Sierra Vista Specific Plan

Unit Transfer Summary for Westbrook Parcel WB-4

Amended Tentative Map for SVSP Parcel WB-4

COVER SHEET
AMENDED TENTATIVE SUBDIVISION MAP
for

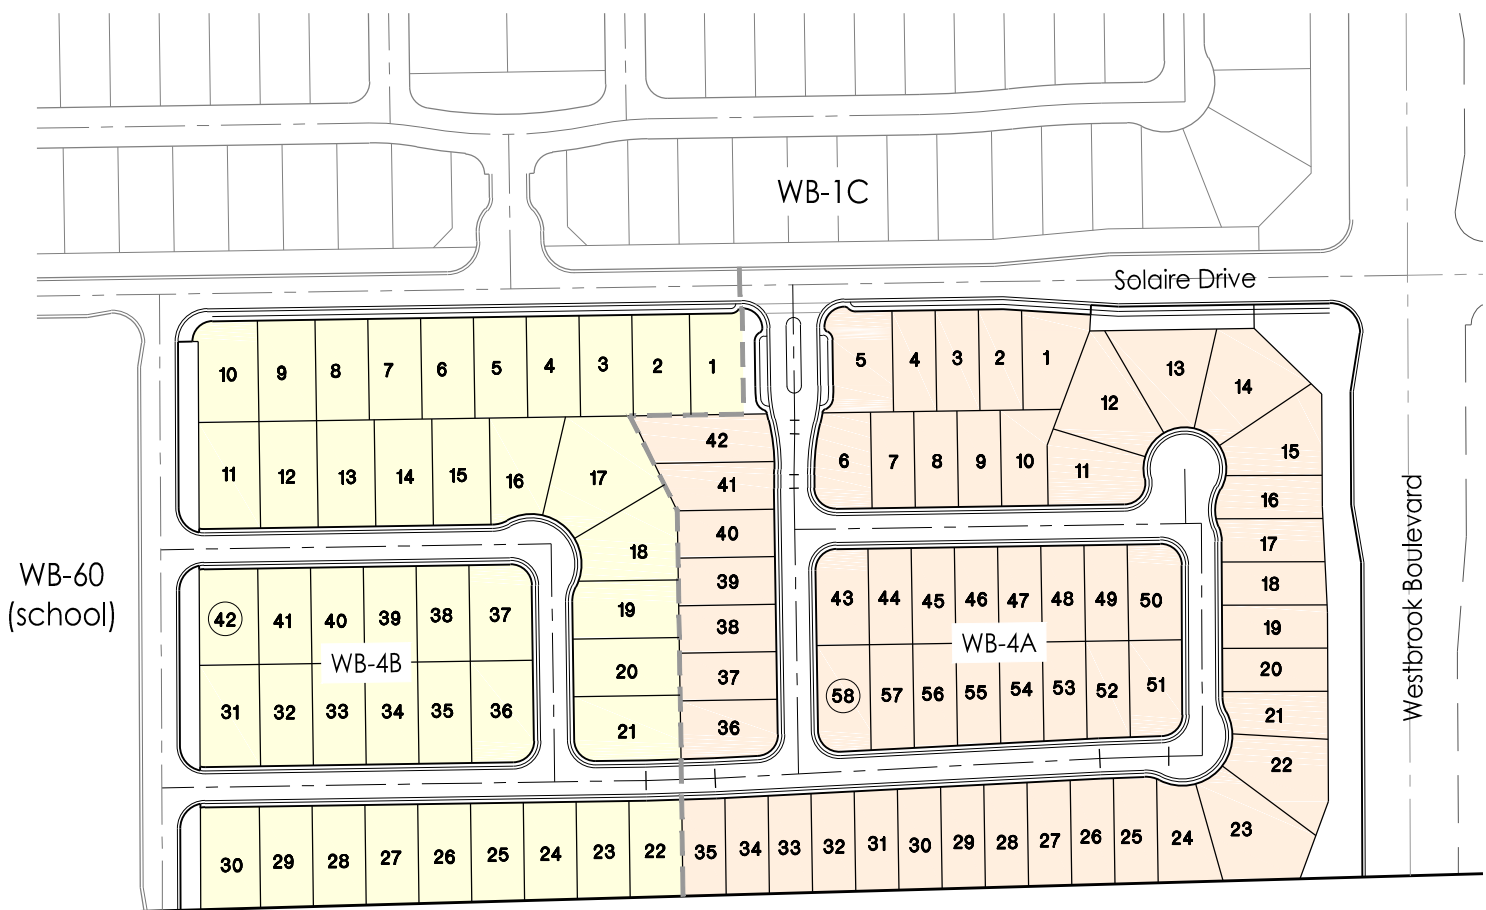
Approved Tentative Map
89 Lots (55'x100')

Proposed Tentative Map
WB-4A = 58 Lots (45'x100')
WB-4B = 42 Lots (55'x100')
100 Total Lots
